# INNER WEST COUNCIL

## DEVELOPMENT ASSESSMENT REPORT

<b>Application No.</b>	DA201800232
<b>Address</b>	15 Robert Street, Petersham
<b>Proposal</b>	To demolish the existing improvements, subdivide the land into 3 Torrens Title lots and a construct a 3 storey boarding house on each lot.
<b>Date of Lodgement</b>	30 May 2018
<b>Applicant</b>	Cracknell and Lonergan Architects P/L
<b>Owner</b>	Ms C Montano
<b>Number of Submissions</b>	34 submissions
<b>Value of works</b>	\$1,032,500.00
<b>Reason for determination at Planning Panel</b>	Number of submissions received exceeds officers delegation
<b>Main Issues</b>	Proposed subdivision pattern, streetscape impacts, amenity impacts on neighbouring properties, departure from the maximum allowable FSR, insufficient on-site car parking, insufficient building setbacks and excessive bulk and scale.
<b>Recommendation</b>	Refusal

Figure 6: Proposed 3 lot subdivision

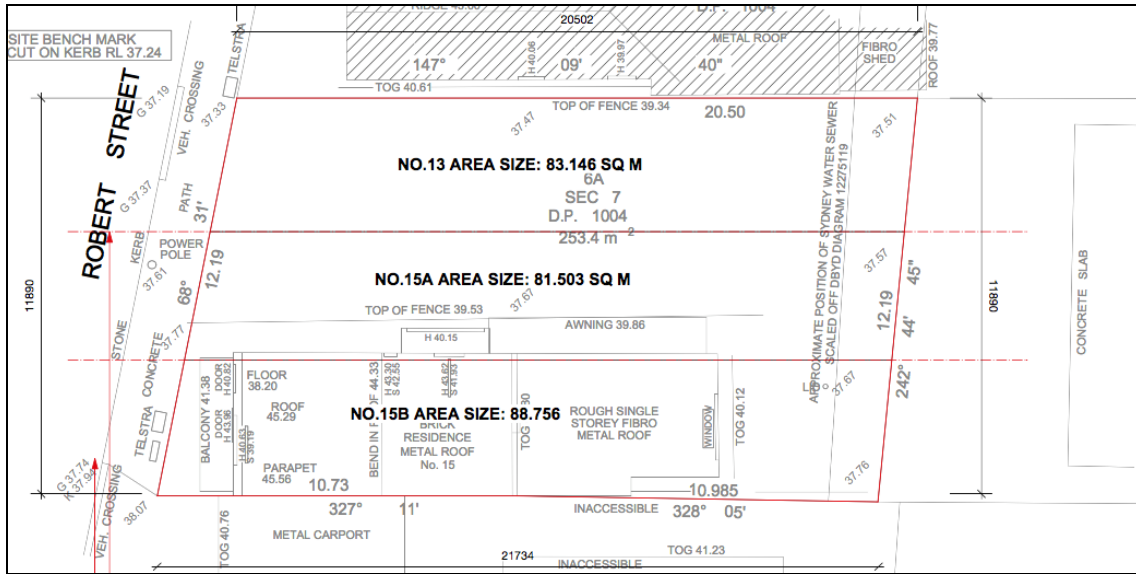
The subdivision would result in three (3) lots which are inconsistent with the adjoining and prevailing subdivision pattern in the streetscape. This is depicted in the diagrams below which show the proposed subdivision of the allotments and the surrounding subdivision pattern:

In view of the above, the proposed development is not considered to satisfy the objectives of Part 3.2.2 of MDCP 2011 in that it would not retain the prevailing cadastral character of the street, fails to ensure that new allotments cater for car parking, does not provide suitable building setbacks and does not ensure that subdivision reflects and reinforces the predominant subdivision pattern of the street.
